EAGLE RIVER

WQ CONCERNS AT A GLANCE:

Segment Identifiers: *19050-002*
Parameters of Concern: *Copper, Lead, Silver, Chlorine, Ammonia*

I. Introduction

FIGURE 1
FLOW vs LN HARDNESS
LN HARDNESS = 4.690 - .0006 * FLOW
Flow = 42 cfs
Ln Hardness = 4.58
Flow = 205 cfs
Ln Hardness = 4.49
LN_HARDNESS
5
4.8
4.6
4.4
4.2
4
3.8
3.6
3.4
FLOW
0
200
400
600
800
1000
1200
1400
1600
1800

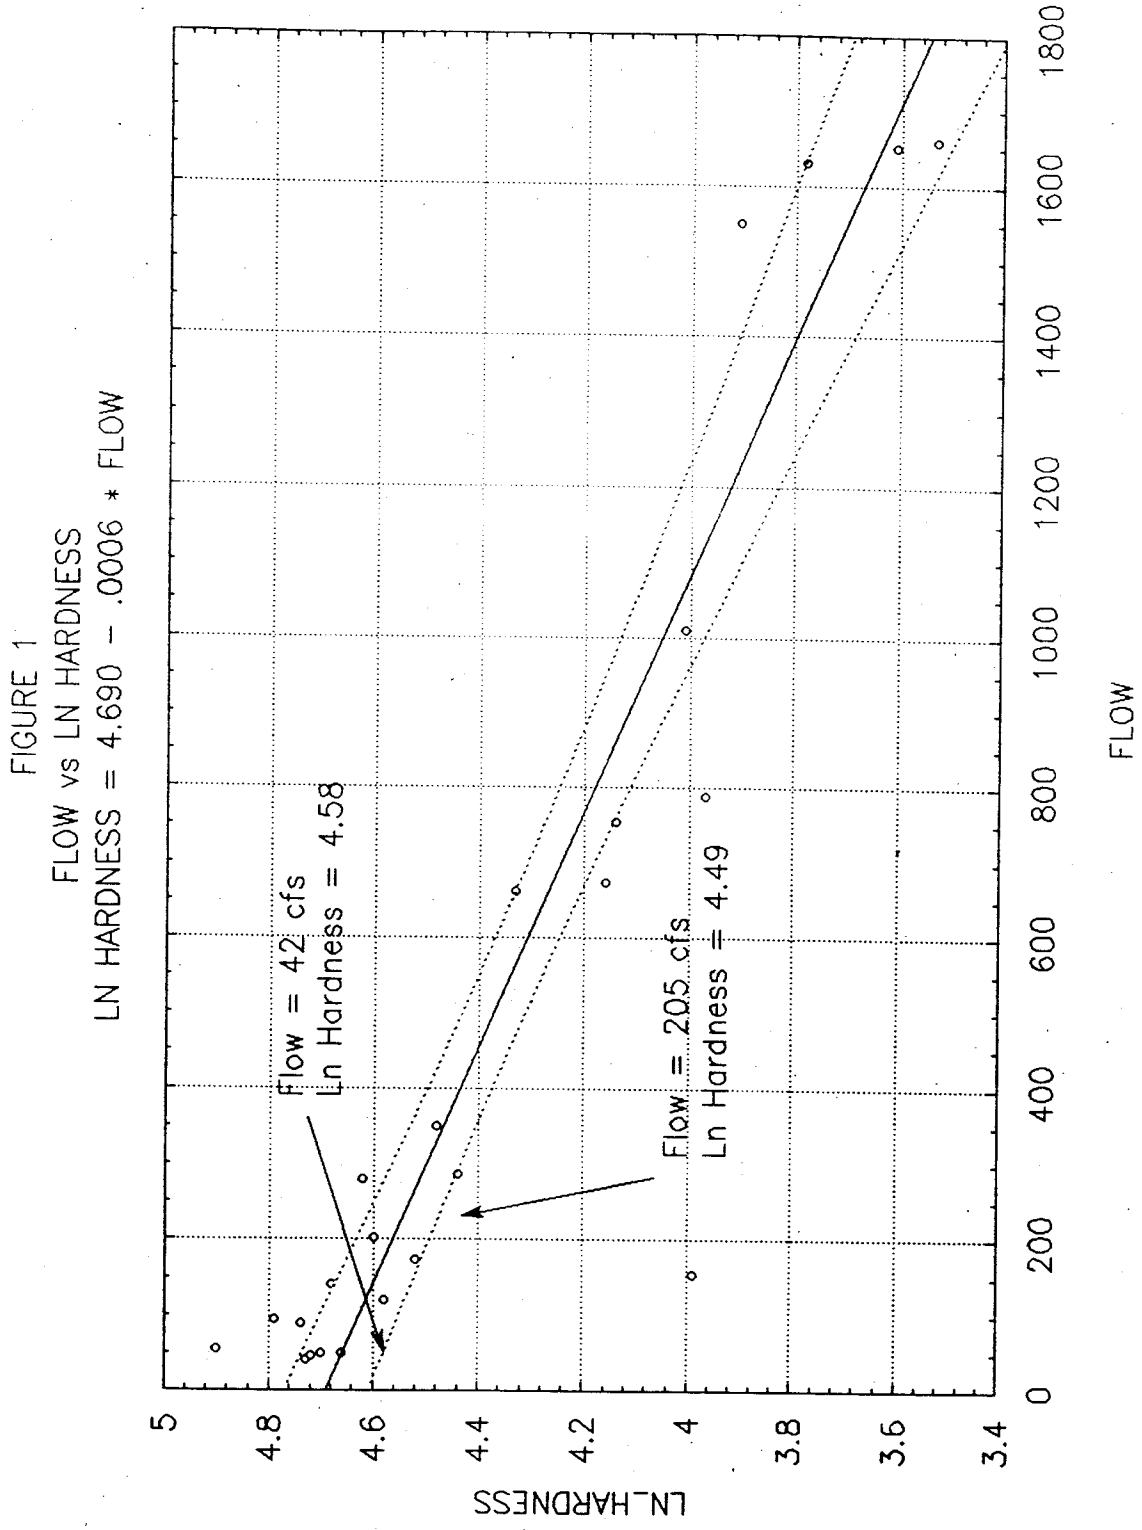
The hardness in the final TMDLs for metals has been changed based on comments received from the MOA. In calculating the criteria for the draft TMDLs, hardness data were arranged seasonally, and the fifth percentile for each season was selected. The MOA submitted data showing that flow and natural logarithm (ln) of the hardness are inversely related; that is, high flow is correlated with low ln hardness and low flow is correlated with high ln hardness. This means that a low flow and a fifth percentile hardness were unlikely to occur together, so using both of these parameters to determine the loading capacity was unnecessarily stringent. EPA concurred with this comment and, in the final TMDLs based the criteria on the fifth percentile hardness that corresponds to the low flow for each season. The low flow is represented by the 7 day, 10 year low flow (7Q10). A 7Q10 flow is the average of 7 consecutive days flow that has a one-in-ten chance of occurring in any given year.

Figure 1 shows the correlation between flow and ln hardness (solid line) as well as the 90 percent confidence interval around the line (dotted lines). The lower dotted line represents the 5th percentile, which means that, for a particular flow, the corresponding ln hardness will be greater than that value 95 percent of the time. Similarly, the upper dotted line represents the 95th percentile.

The fifth percentile ln hardness corresponding to summer low flow (205 cubic feet per second, cfs) is 4.49, which translates to a hardness of 89 mg/l as calcium carbonate ($CaCO_3$). There are no hardness data corresponding to winter low flow (31 cfs). In this case, EPA determined that it was not appropriate to extrapolate beyond the range

of the data. Therefore, EPA used the lowest flow for which hardness data were available, 42 cfs, resulting in a ln hardness of 4.58, which corresponds to a hardness of 97 mg/l $CaCO_3$. These values compare with hardness values of 33 and 66 mg/l $CaCO_3$ for summer and winter, respectively, in the draft TMDLs.
